## V2500 A5/D5 SERIES PROPULSION SYSTEMS SERVICE BULLETIN

This document transmits Revision 7 to Service Bulletin EV2500-72-0302

# V2500-ENG-72-0302

ENGINE – HP TURBINE ROTOR AND STATOR ASSEMBLY – INTRODUCE FIRST AND SECOND STAGE  
TURBINE BLADES WHICH HAVE PROTECTIVE COATING IN THE DAMPER POCKET AREA UNDER THE  
PLATFORM

Modification of the Stage 2 High Pressure Turbine Blade Assembly  
Figure 4 (Sheet 1)

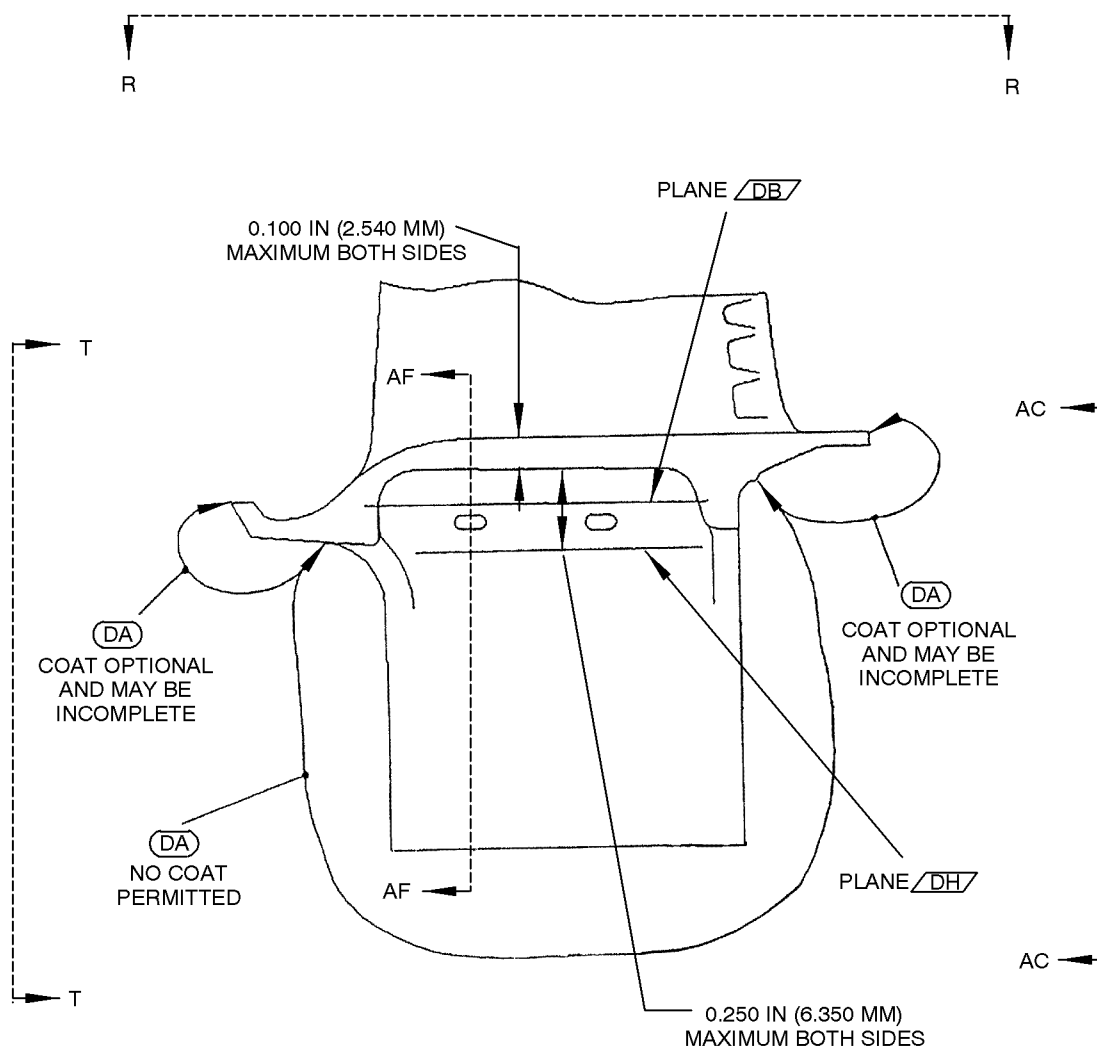
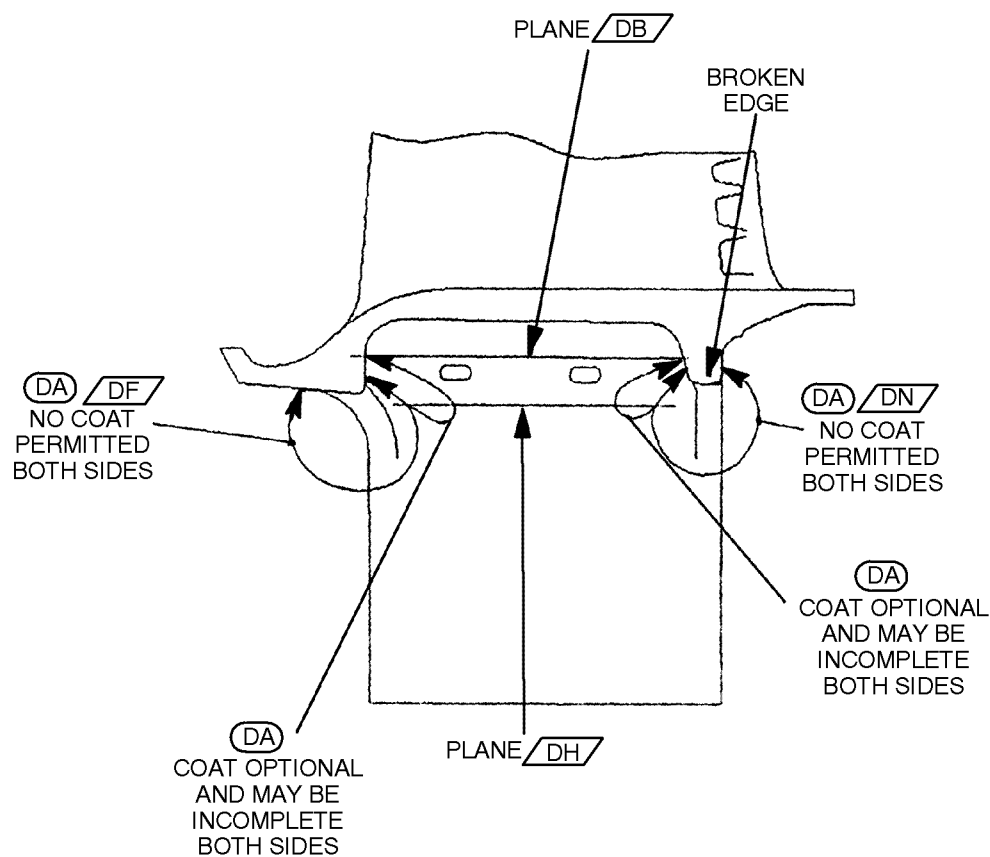
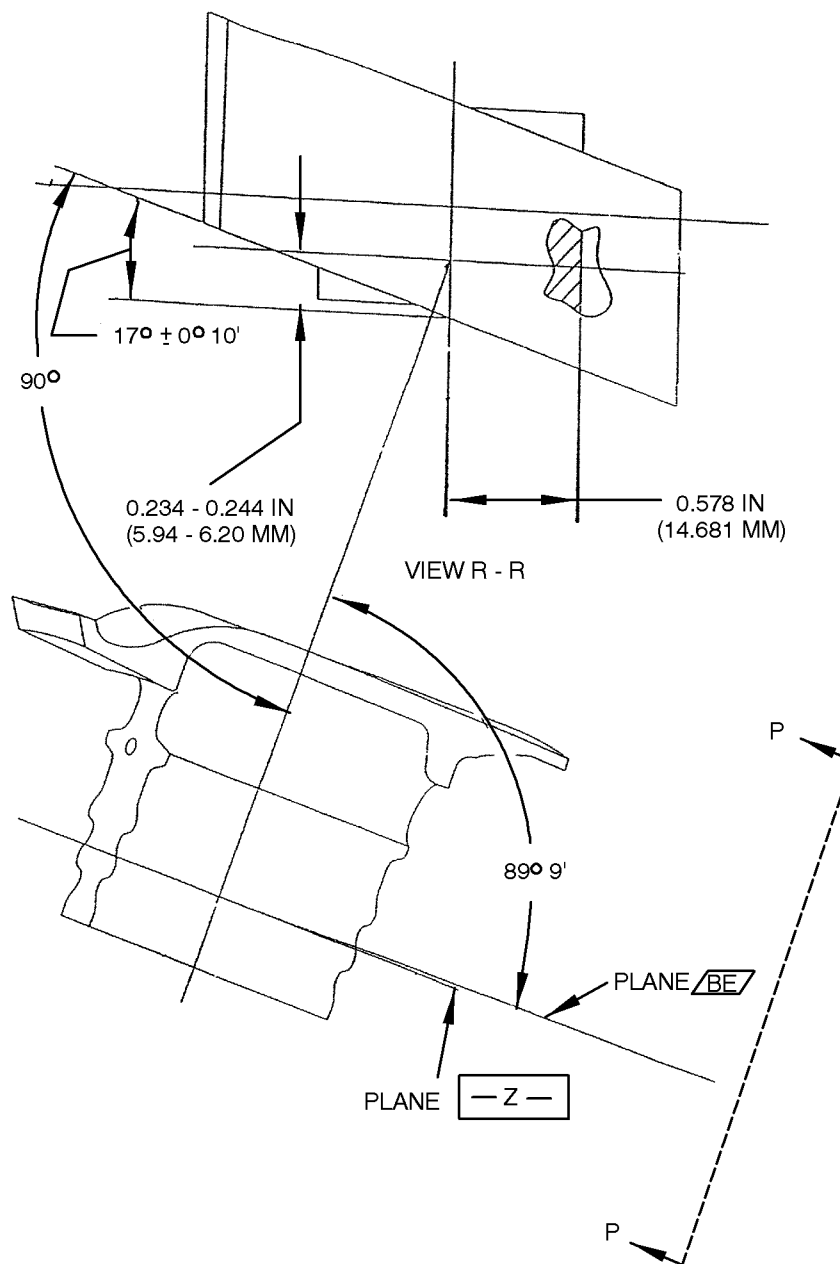
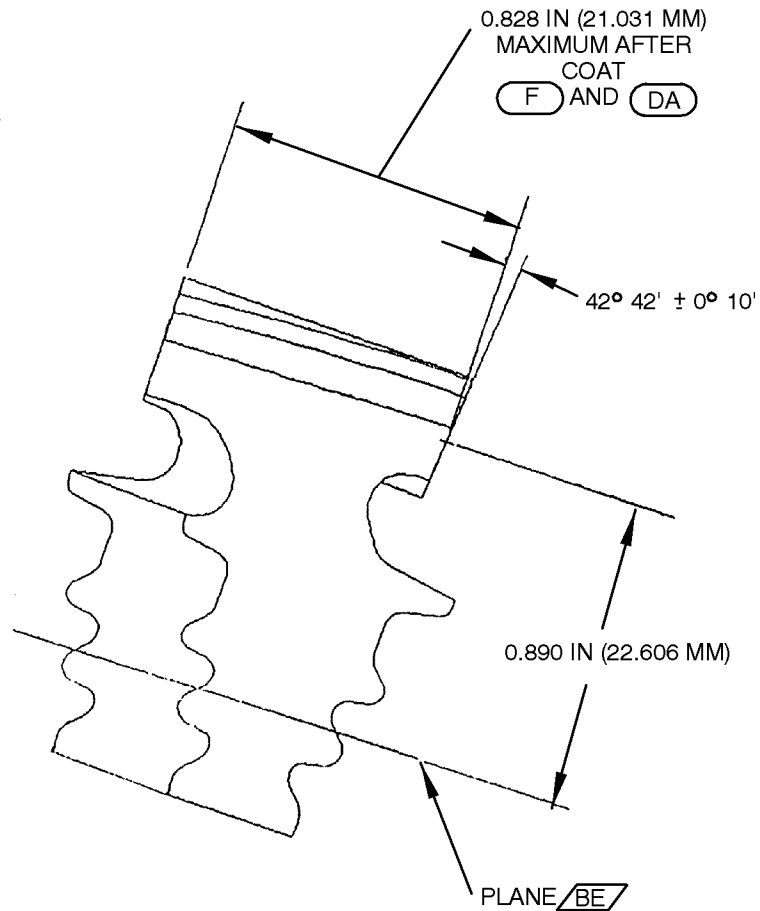
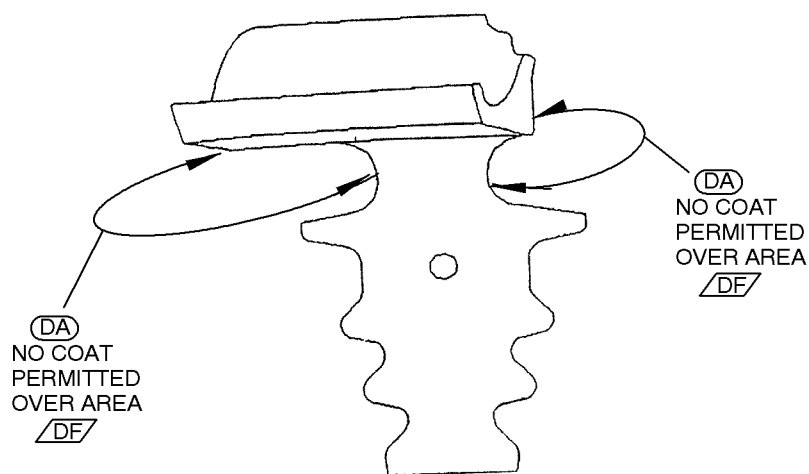
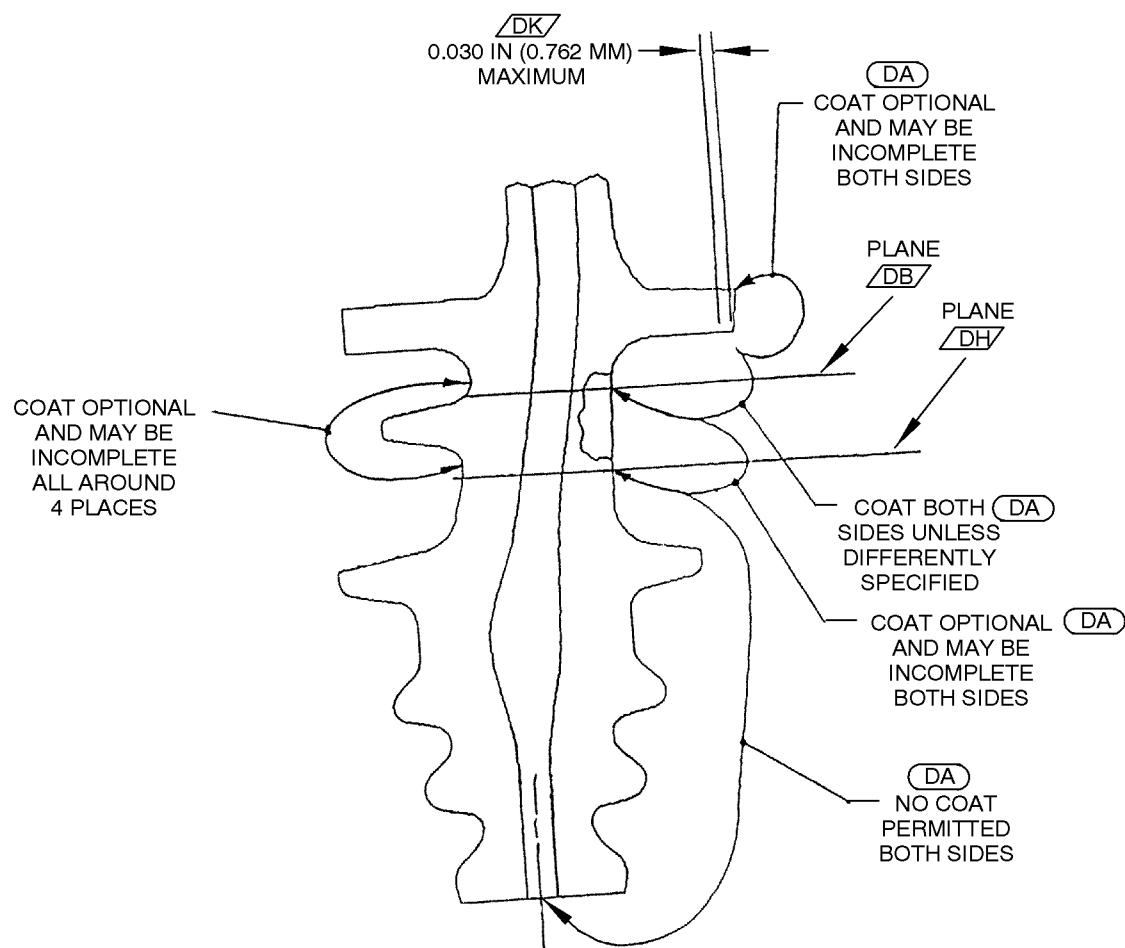
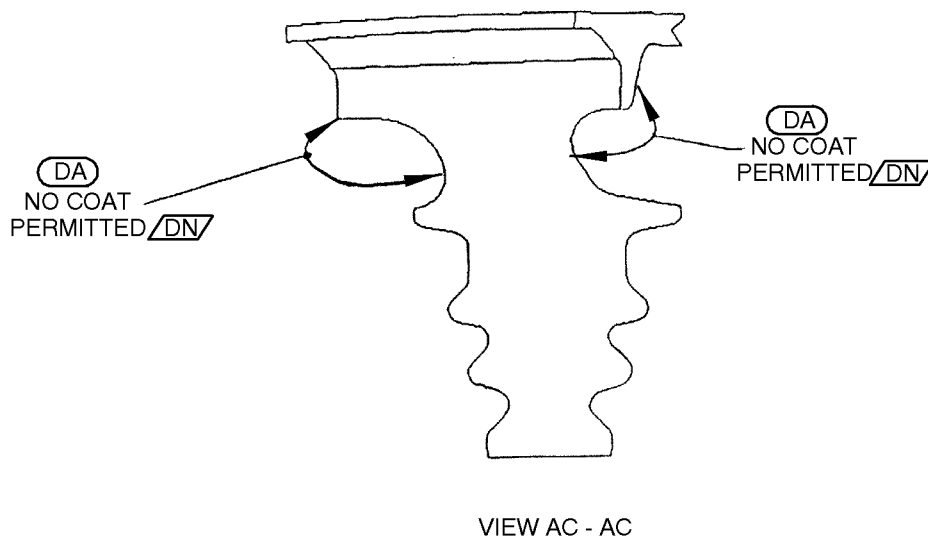
(i) Do a modification of the Stage 2 High Pressure Turbine Blades 2A2202 and 2A2202-001 (72 off). See Reference (8), Chapter/Section 72-45-32 for the applicable engine model. See Figures 3 and 4.

- (9) Dry abrasive blast the under platform area by the procedure specified. Make sure that the areas which need protection are properly masked (root serrations, root openings and coated areas).

Refer to Reference (9) Chapter/Section 70-38-26, Surface Treating. See Figure 4.

Refer to Reference (9) Chapter/Section 70-38-26, Surface Treating. See Figure 4.

Refer to Reference (9) Chapter/Section 70-37-03, Heat Treating. See Figure 4.

Refer to Reference (9) Chapter/Section 70-37-03 Heat Treating. See Figure 4.

Refer to Reference (9) Chapter/Section 70-37-03, Heat Treating. See Figure 4.
